AMPLIFIER-POWER SUPPLY AM-598( )/U

FSC 5820

FIGURE 1

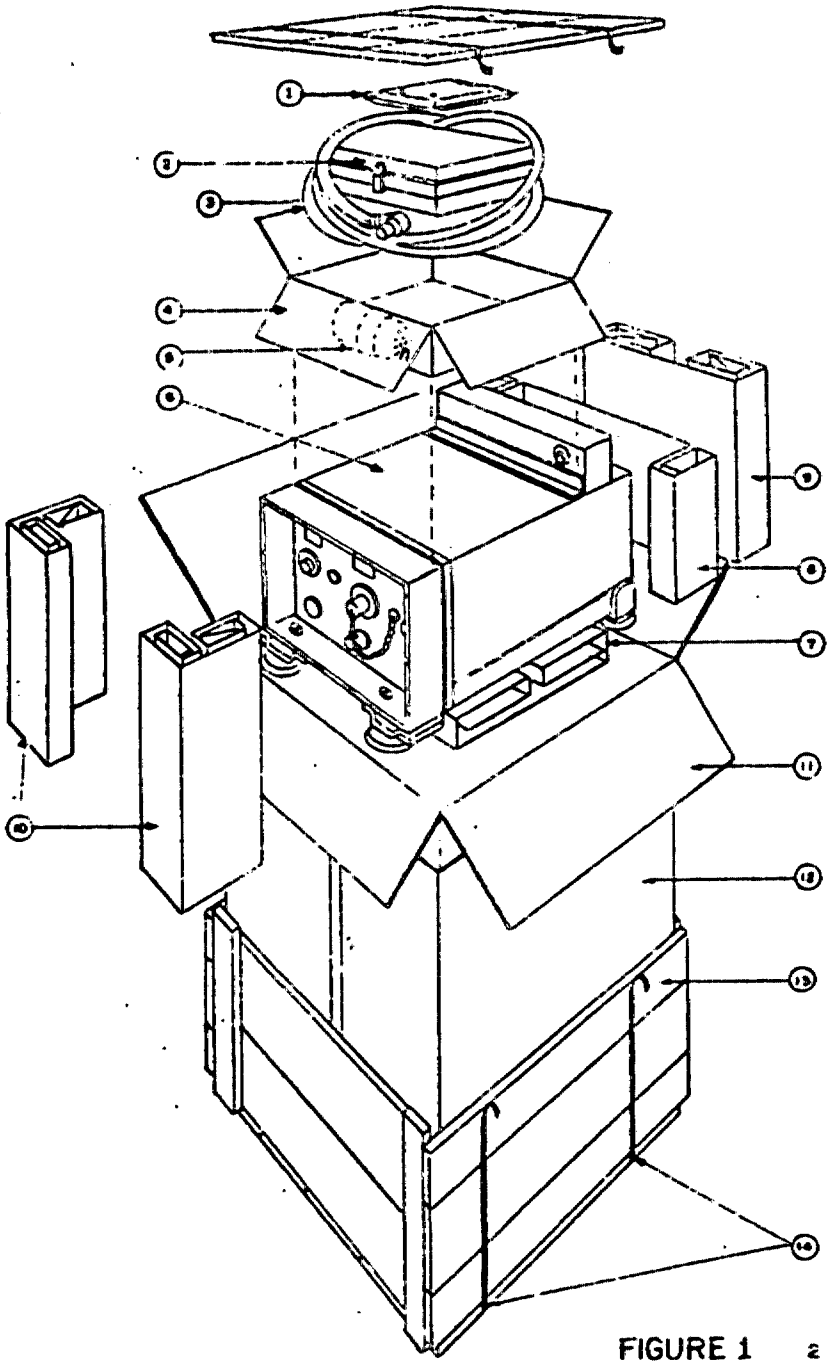
6. Pages 23 and 24, Section 5: Delete in its entirety and replace with the following:

5.1.1 Level A.- Each Amplifier-Power Supply AM-598/U shall be packaged in accordance with item 1 through 11 of Figure 1, Table I.

5.1.2 Level C. Each Amplifier-Power Supply AM-598/U shall be packaged in accordance with item 1 through 11, of Figure 1, Table I.

5.2.1 Level A.- Each Amplifier-Power Supply AM-598/U shall be packed in accordance with items 12 through 14, of Figure 1, Table I.

5.2.2 Level B.- Each Amplifier-Power Supply AM-598/U shall be packed in accordance with items 12 and 13 of Figure 1, Table I, except the nailed wood box shall be class 1, style 4, or cleated plywood box, style A, Type IV, Class 1.
